Invitation to Public Comments

Sub: Invitation to Public Comments for issue of Access Permission to install MS/HSD retail outlet on LHS at Km. 143.630 of NH-75 in Survey number 24/5 and 25/6 of Chikkagondanahalli Village, Channarayapatna-Taluk, Hassan-District, Karnataka state-Reg;

Sub: Design, Engineering, Construction Development, Finance, Operation and Maintenance of Devihalli to Hassan section from km 110.0 to 189.5 of NH-48 in the State of Karnataka under NHDP Phase IIIA on DBFOT Basis – **Regarding Access Permission to install MS/HSD retail outlet on LHS at km 143.630 of NH-75 in survey number 24/5 and 25/6 of Chikkagondanahalli village, Channarayapatna Taluk.**

LINEAR PLAN SHOWING FROM KM. 142+130 TO KM. 145+130, NH-75.

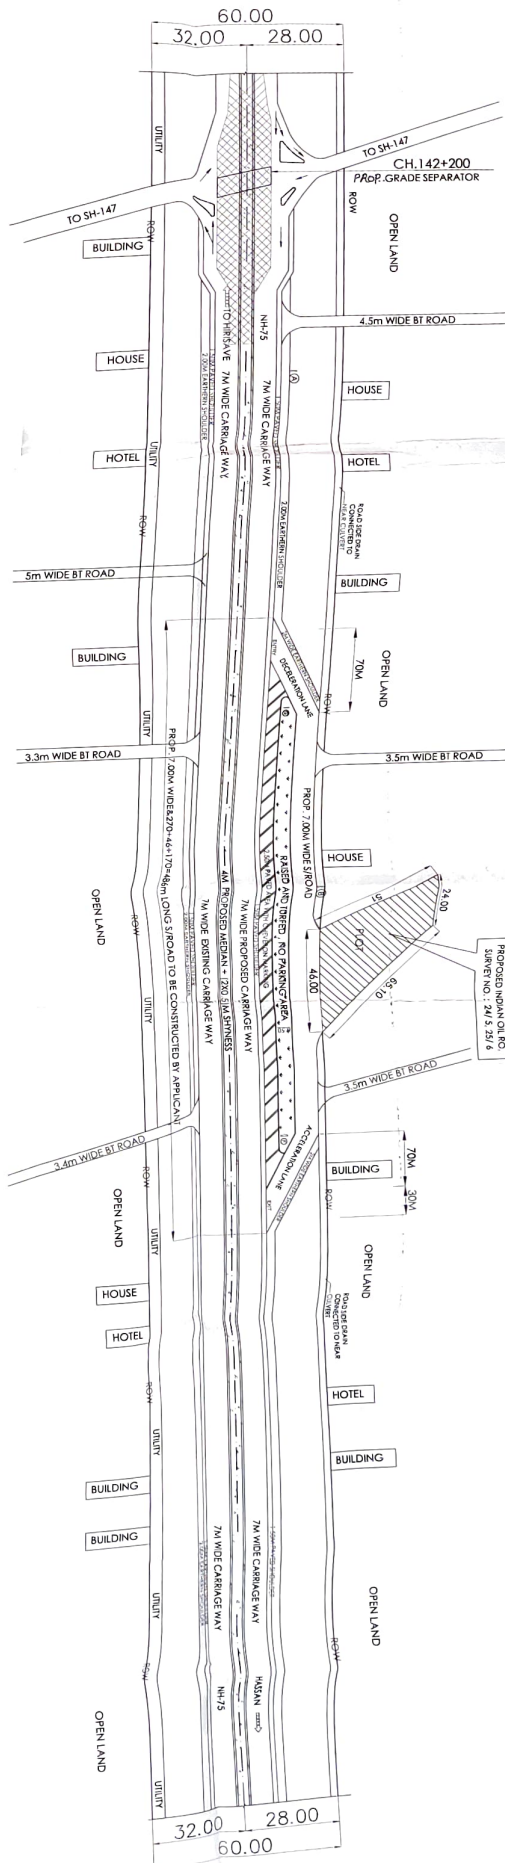
1. There exist a grade separator at km.142.200. The same has to be indicated in the key plan along with approached marked on it. It is corrected and incorporated in the Linear plan.
2. The ROW as indicates at section A-A' is 28m, the same does not tally with it breakup details i.e. (2.5+7+1.5+2.5+4+7). It is corrected and incorporated in the layout plan.
3. A section through culvert is shown with 50mm thick bottom neat cement finish whereas proposed layout plan has no culvert marked. It is shown as cross section of the front culvert 1.0x1.0m in the layout plan. It is corrected and incorporated in the layout plan.
